# Product Change Notification

**Change Notification #:** 112704 - 00  
**Change Title:** Intel® Server System R2312BB4GS9  
PCN 112704-00, Product Design  
Update System PSU Bracket  
**Date of Publication:** November 07, 2013

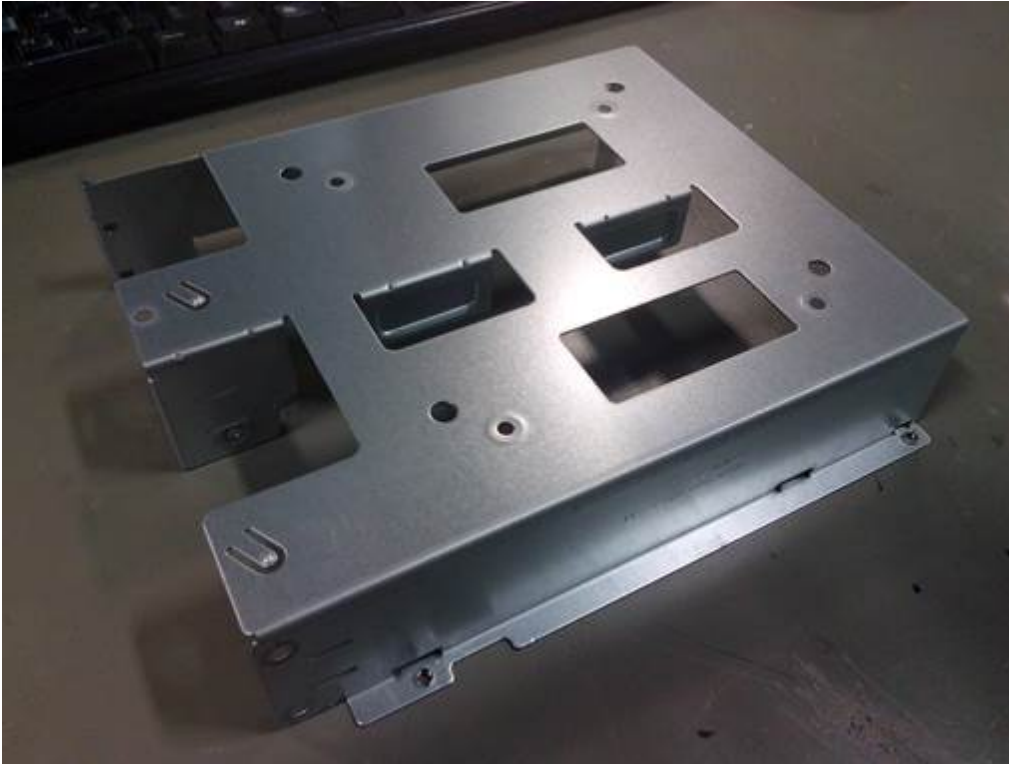
Update the Power Supply bracket to remove middle punch. Please refer to below pictures for details:

Pre-change:

Post-change:
